RIDGE PORT 3RD ADDITION

RE: S/D 99-84 -- Final Plat of RIDGE PORT 3RD ADDITION

At the regular meeting of the Subdivision Committee of the Metropolitan Area Planning Commission on Thursday, December 2, 1999, the above captioned plat was considered. The action of the Committee was to approve the final plat, subject to:

CASE NUMBER: S/D 99-84 -- RIDGE PORT 3RD ADDITION

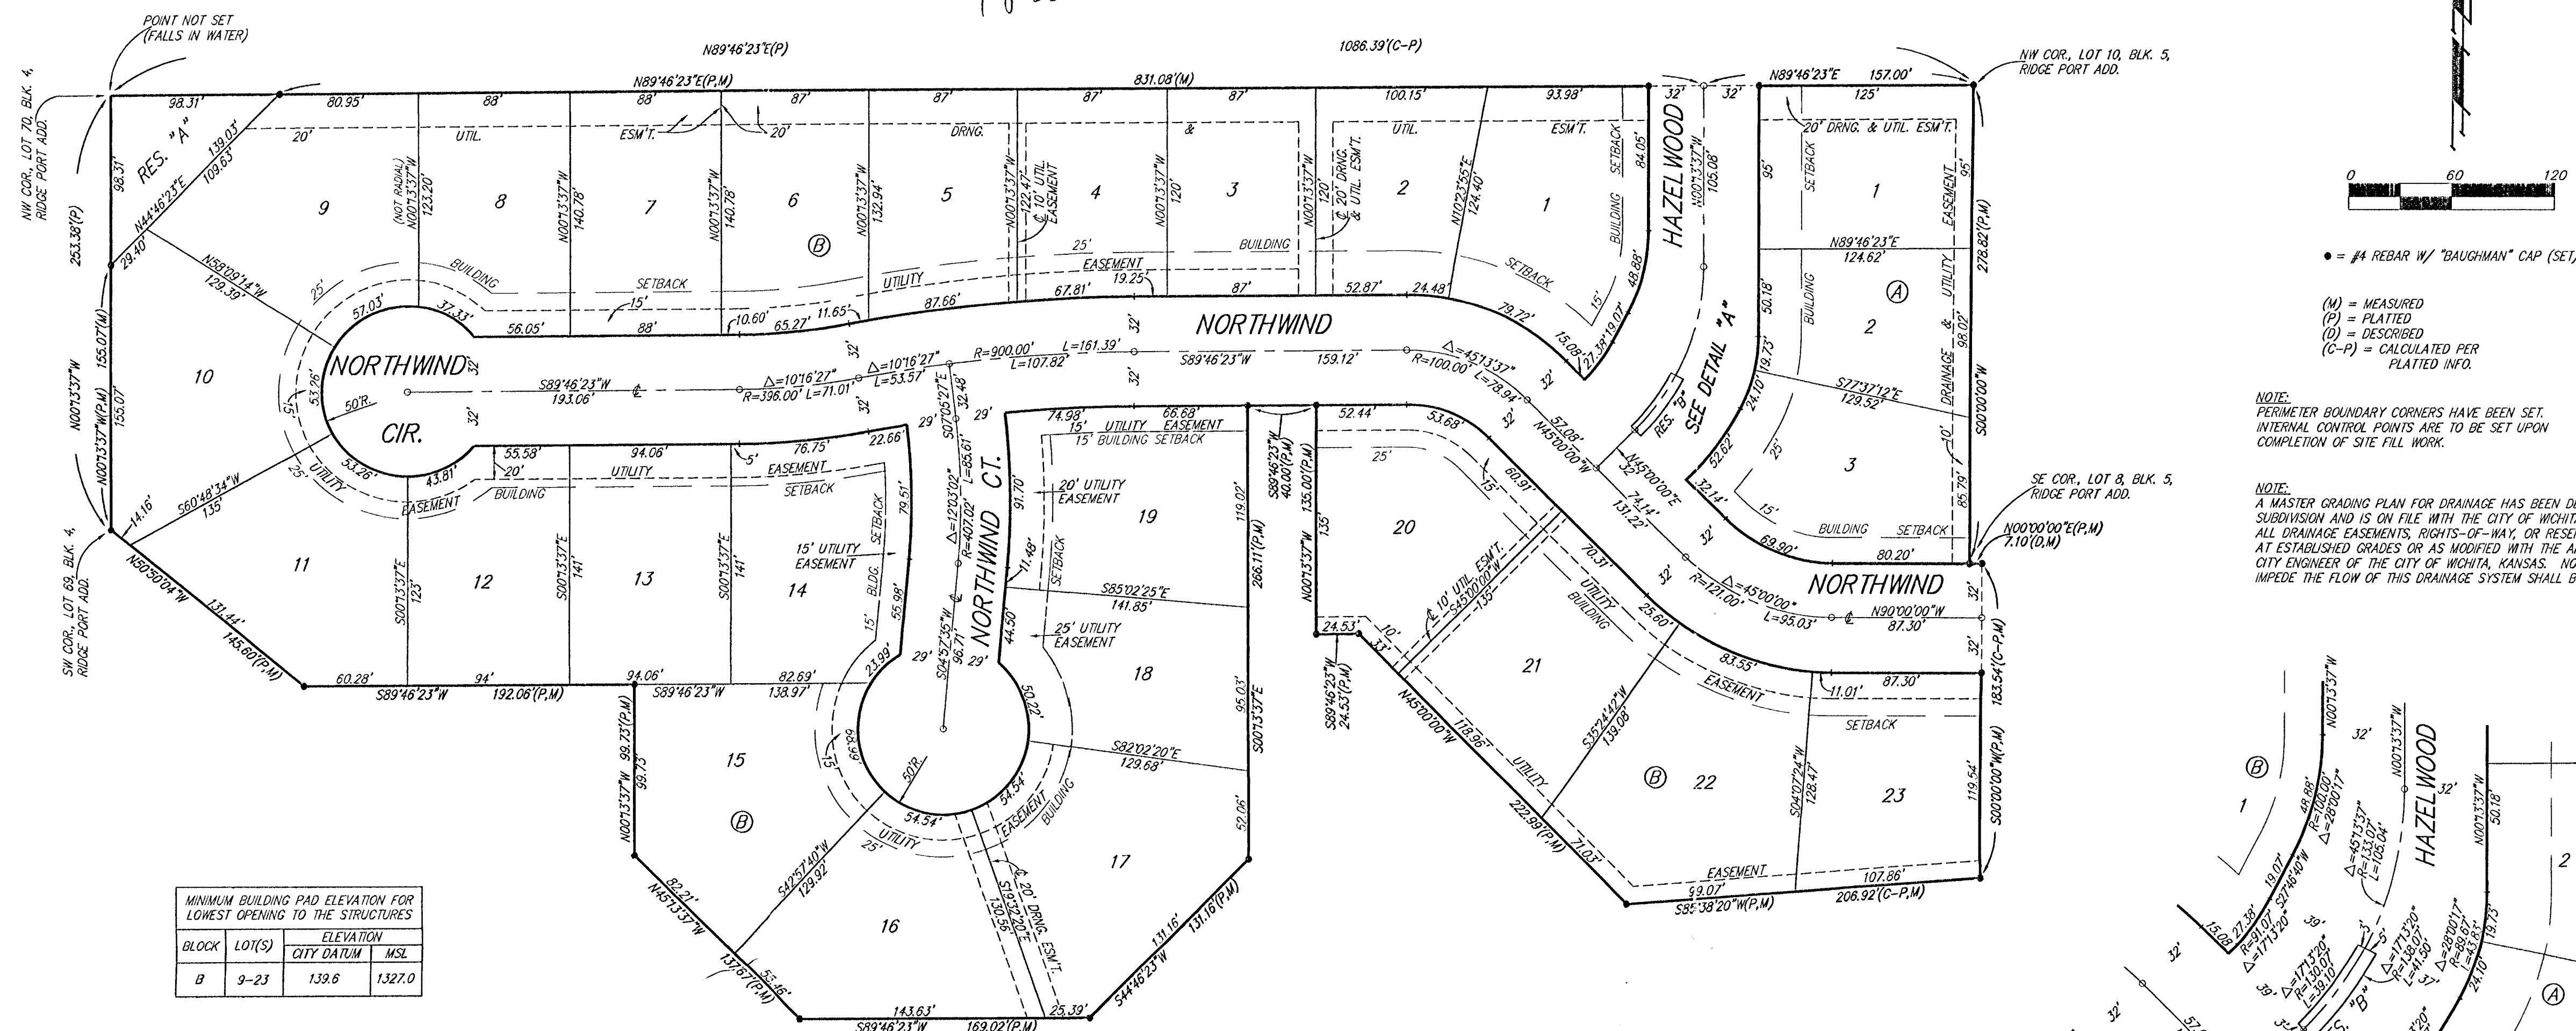
- F. City Fire Department needs to comment on the plat's street names. *The final plat tracing needs to indicate the following street name changes: Northwind Court to Northwind Circle, Northwind Circle to Northwind Court.*

- S. The representatives from the utility companies should be prepared to comment on the need for any additional utility easements to be platted on this property. ***KGE and Southwestern Bell have requested additional easements which have been denoted on the final plat.***
- T. The applicant is reminded that a disk shall be submitted with the final plat tracing to the Planning Department detailing this plat in digital format in Release 13 version of AutoCAD. This will be used by the City and County GIS Department.

The final plat has made the requested street name changes.
